Amendment No. 0005
13 September 2002

SUBJECT: **Amendment No. 0005** to Request for Proposal Solicitation Package
for Design and Construction of **REPLACE FAMILY HOUSING, MINOT AFB, ND.**
Solicitation No. DACA45 02 R 0024.

REPLACE FAMILY HOUSING
EXISTING TOPOGRAPHY
AND STORM DRAINAGE
AREA 3

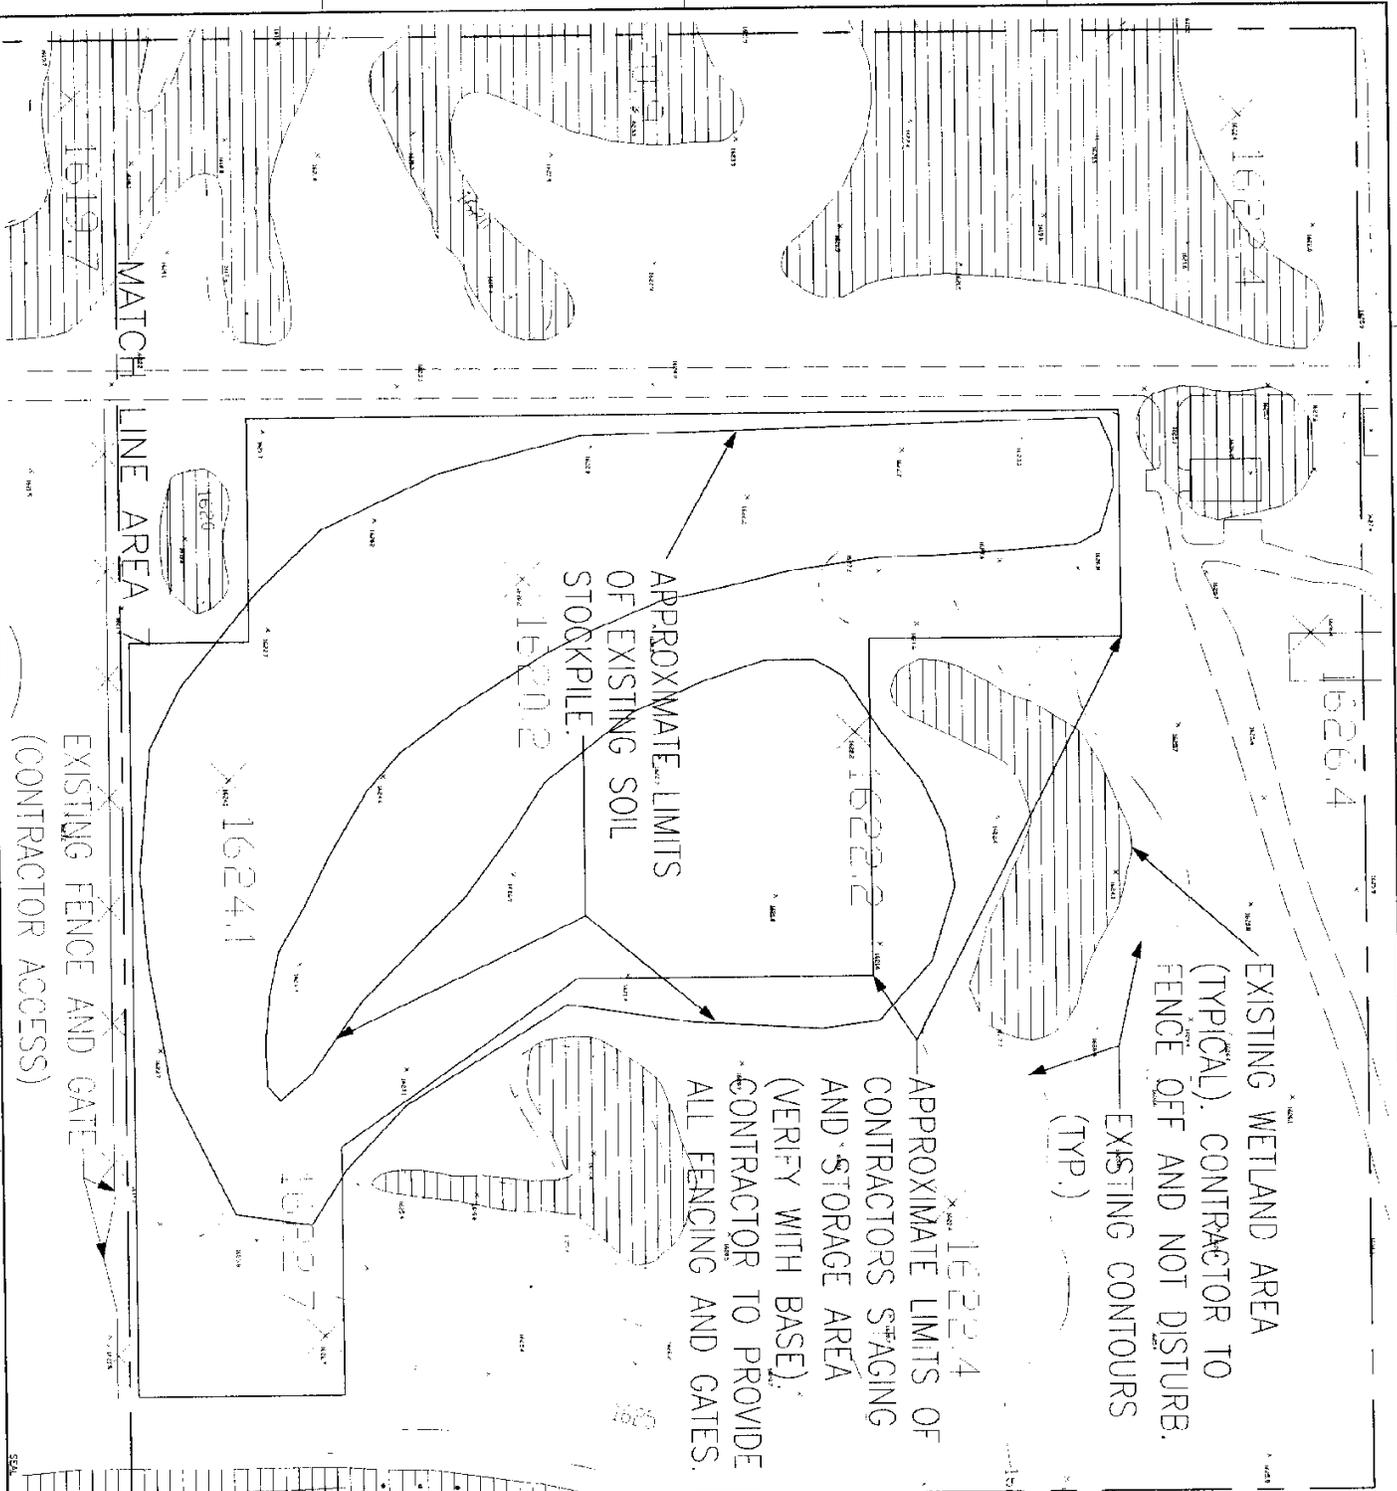
1. **Sheet C1.03**, Revise drawing sheet C1.03 in accordance with attached Sketch.

REVISION IN ACCORDANCE WITH AGREEMENT # 5 - 9/10/02
U.S. ARMY CORP. DISTRICT
CIVIL ENGINEERS
DANIEL WILSON
